SERVICE BULLETIN NO. MSB1078-165

ATA-Code: 32-20 Nose Landing Gear

G 115C/D/E/EG

Fig. 1

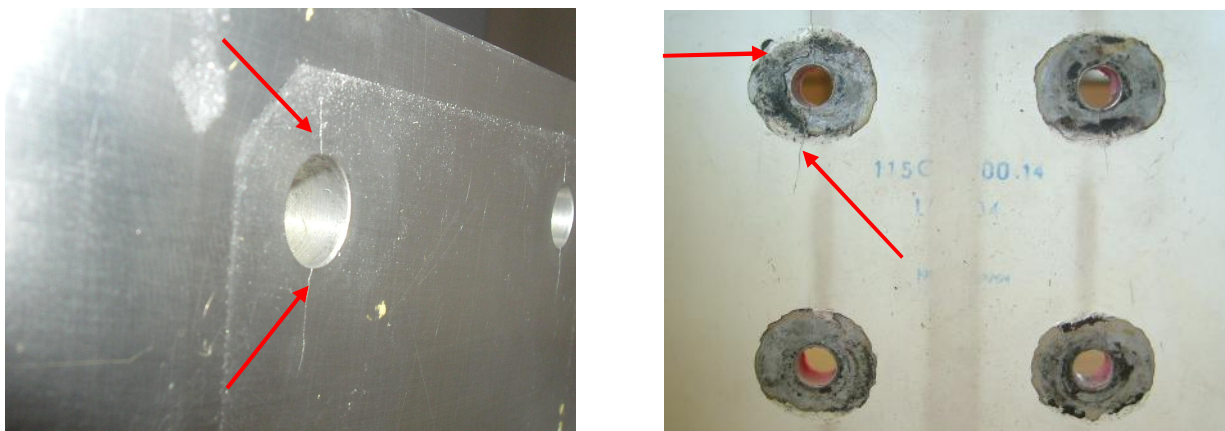
Grob received a report of a fleet customer pertaining to cracks in the nose wheel fork P/N 115C-5200.14. The cracks were found in the attachment holes, both, at the painted unit and stripped unit. See Fig. 1 for details.

The cracks were found during regular maintenance. The affected aircraft had accumulated a substantial number of landings during demanding training operation. The cracks were identified as fatigue cracks, caused purely by the vast number of landings. As a precautionary action, the nose wheel forks have to be NDT tested, the service life will be limited to 8000 landings.

- 1.8.1. Ensure that the aircraft is safe for parking I.A.W. MM chapter 10-10.
- 1.8.2. Remove nose wheel and mounting fork I.A.W. MM chapter 32-20.
- 1.8.3. Check mounting fork for cracks radiating from the four mounting holes. (See enclosed pictures in para. 1.5).

1.8.4. In case any cracks are apparent or suspected in the paint or in the holes confirm by stripping away the paint, verify whether or not cracks are evident by using 10x magnifying glass or an approved NDT procedure. Replace any cracked mounting fork with a new nose wheel fork P/N 115C-5200.14.

For nose wheel forks with more than 8000 landings, where no cracks were found, the inspection has to be repeated every 100 hours until replacement.
